# UNITED STATES PATENT AND TRADEMARK OFFICE

10/674,147

<b>Office Action Summary</b>	Application No. 10/674,147	Applicant(s) MCGRATH, JAMES J.	
	Examiner Chi Q. Nguyen	Art Unit 3635

### **DETAILED ACTION**

FIG. 6

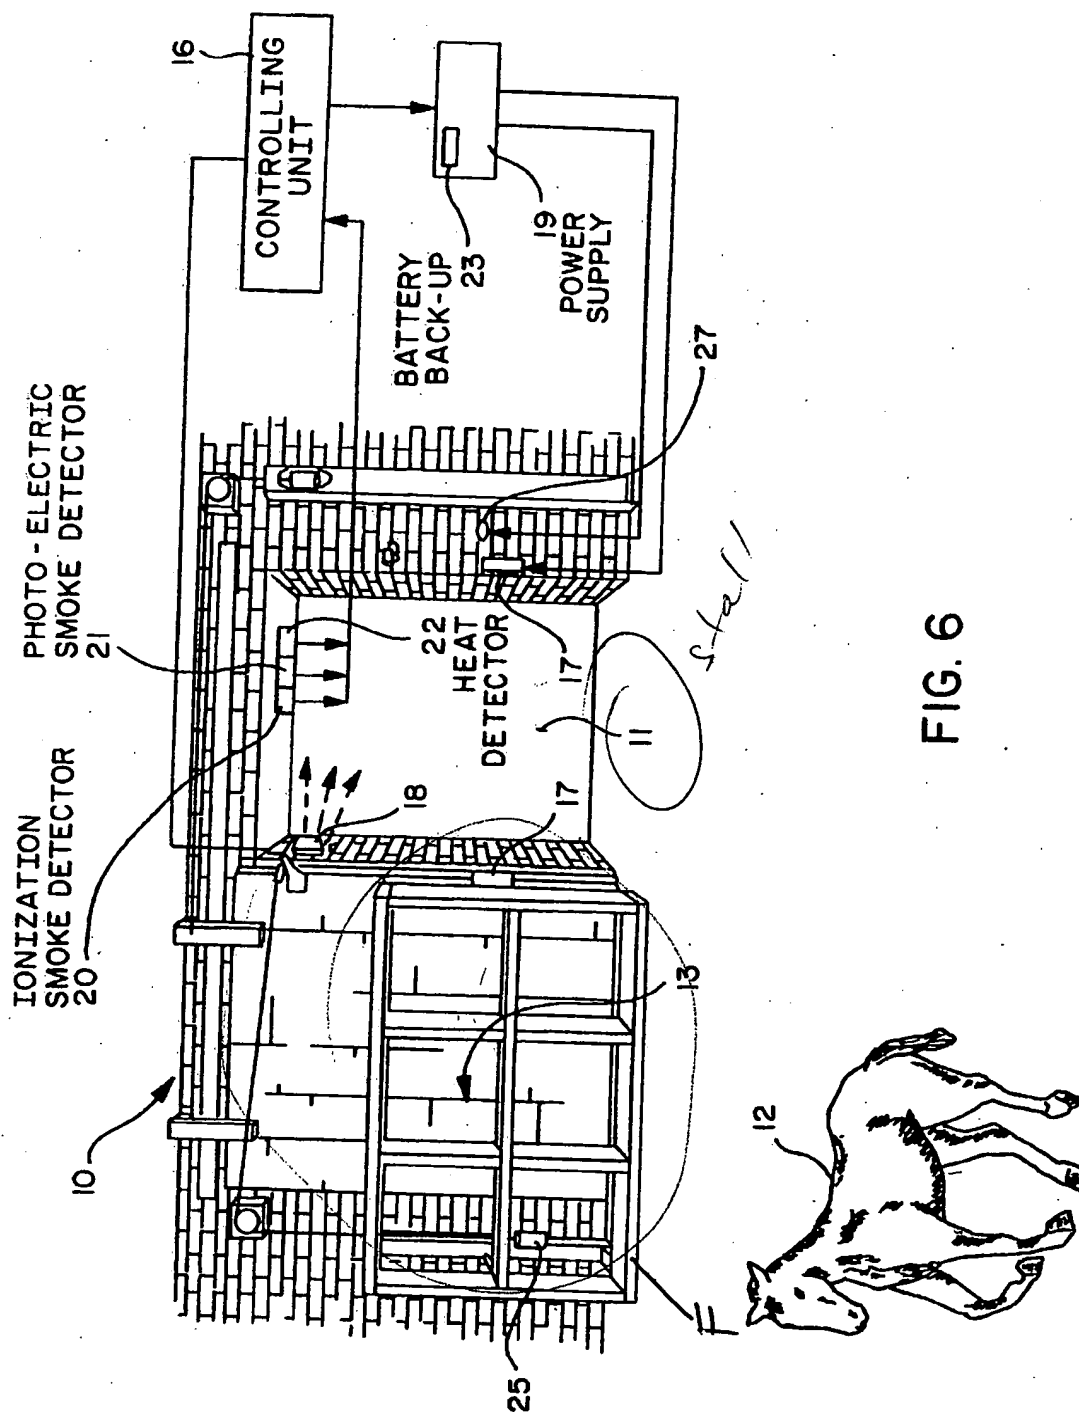
Maus teaches a safety system for horse comprising an access panel including a door 13 and a frame F (see attached of Fig. 6) peripherally surrounding said door, said door being attached to said frame, and a stall or cage 10 having side and rear walls and attached to said access panel frame, wherein said access panel is fire protection rated (see col. 7, line 60). Maus does not teach expressly the cage having a plurality of openings for ensuring fluid communication between an interior portion of the cage and surrounding space. Demurjian teaches collapsible cage 10 having a plurality of openings on side and end walls (see Fig. 1). At the time of the invention, it would have been obvious to a person having an ordinary skill in the art to modify Maus' stall or cage for Demurjian's cage having a plurality of openings for ventilation purposes thus preventing horses from suffocation.

And further comprising an environmental sensing device comprises a smoke detector 21 (Fig. 6).

Wherein said sensing device comprises a heat sensor 22 (Fig. 6).
